**UNITED STATES DEPARTMENT OF TRANSPORTATION  
NATIONAL HIGHWAY TRAFFIC SAFETY ADMINISTRATION**

EA15-001

Air Bag Inflator Rupture

**EXHIBIT A**

Figure 1. CT Scans of GM Inflators PSPI-L-FD, PSPI-L YD, and SPI YD <sup>20</sup>

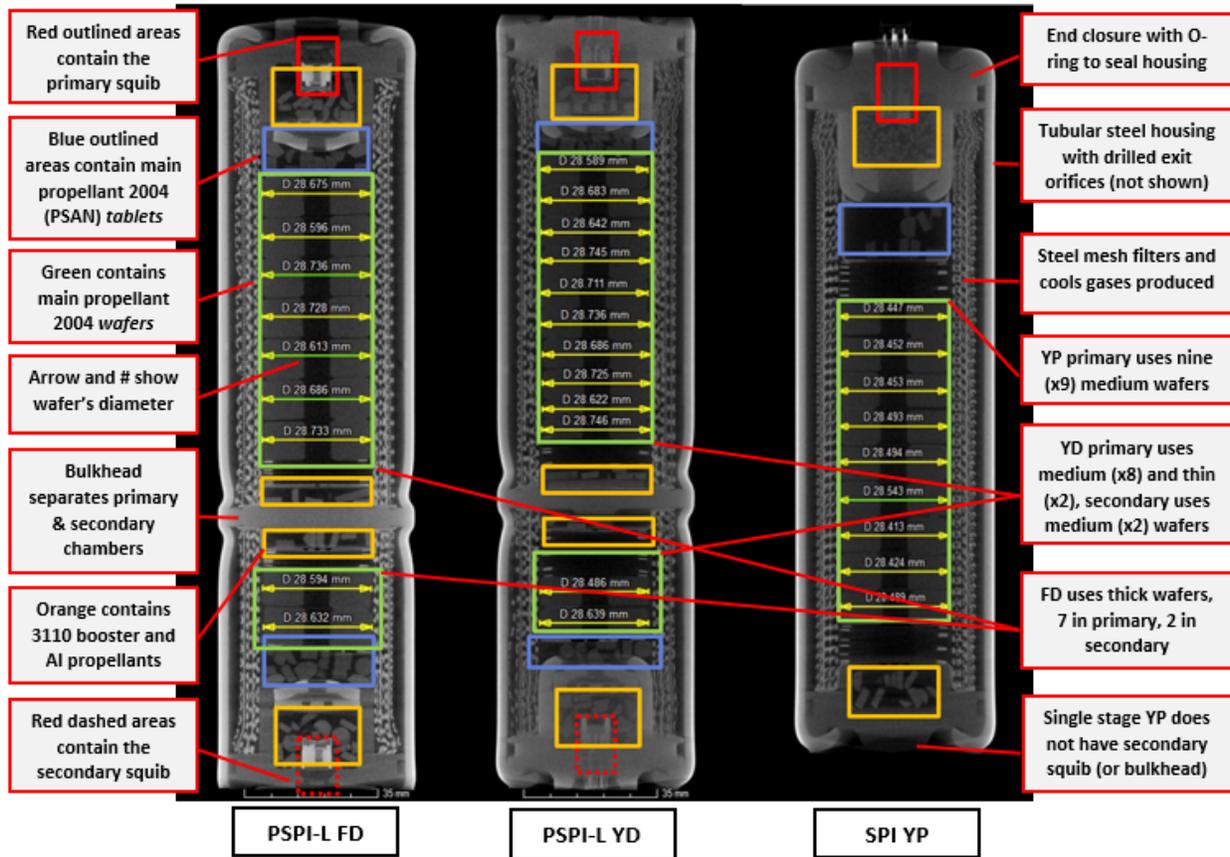
75. Figure 1 depicts an image of three CT<sup>40</sup> scans of the GM specific inflator variants discussed in this report (the YP, YD, and FD (Vibe) variants). The CT scans shown are sections (slices) taken through the center along the long axis of the inflator housing. The scanned section shows the internal components of the inflator assemblies, and notes have been added to highlight relevant individual components. The orientation of the section through the center of the assembly shows the wafer cross section, and software designed to work with CT data can be utilized to estimate the outer diameter of each wafer with good accuracy.

225. *Bulkhead anvil (PSPI-L YD only)*. In all PSPI-L variants, a metal disk bulkhead separates the primary and secondary combustion chambers, as can be seen in Figure 1 for both FD and YD variants. GM’s YD variant has a feature, referred to as an anvil, added to the bulkhead disk that protrudes into the combustion chamber. GM claims that during assembly the anvil contacts the autoignition-booster cup so as to disrupt the seal of that cup, thereby allowing the moisture in the inflator headspace greater access to the booster propellant 3110 within the cup.

**Figure 2: Test design for OATK Accelerated Aging Study (provided by GM)<sup>87</sup>**

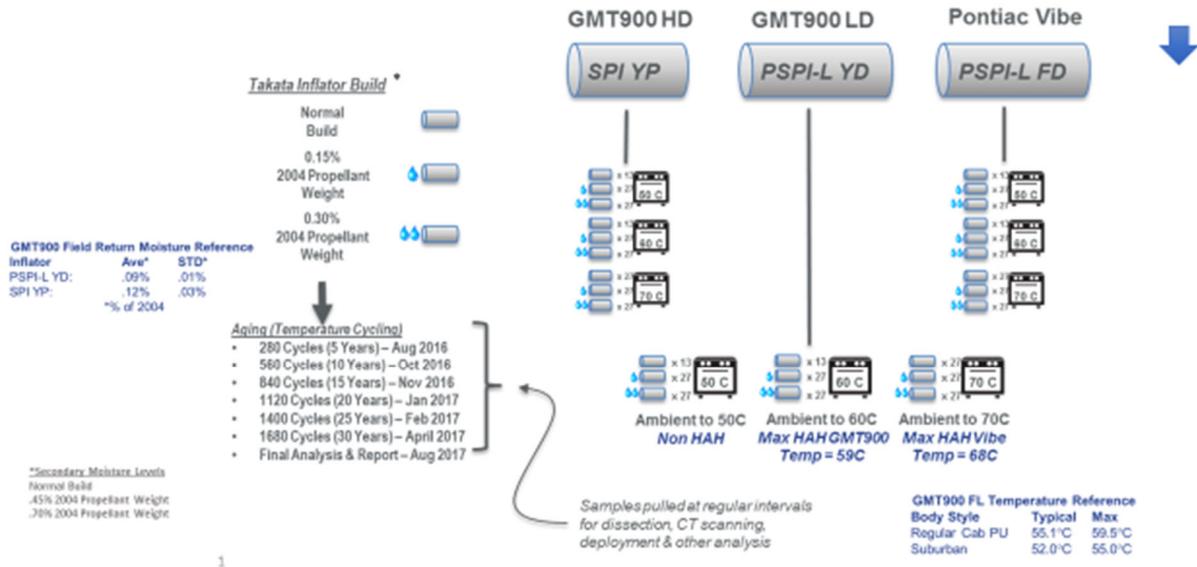
134. Inflators within each variant (YP, YD, and FD) were also separated into three peak temperature cycling groups. The inflators were cycled between laboratory ambient temperature (approximately 23 °C) and either 50 °C, 60 °C, or 70 °C. The 50 °C cycle represents inflators in the field that are not in the high absolute humidity region. As illustrated in Figure 2, the 60 °C cycle represents GMT900 inflators and 70 °C cycle represents Vibe inflators & exposed to the maximum temperature measured in vehicles in Miami, Florida. This also is representative of the 13 C° range of peak inflator surface temperatures measured while various vehicles were exposed to Zone A (e.g. Miami, FL) environmental conditions with solar radiation imposed, as measured in the Atlas Cabin Temperature Study.<sup>88</sup>

<sup>88</sup> The span of 13 C° would cover the GM vehicles as they note Pontiac Vibe peak temperature of 68 °C and the GMT900 vehicles with peak temperatures between 55 °C (Suburban) to 59.5 °C (regular cab Silverado) as noted in Figure 2.
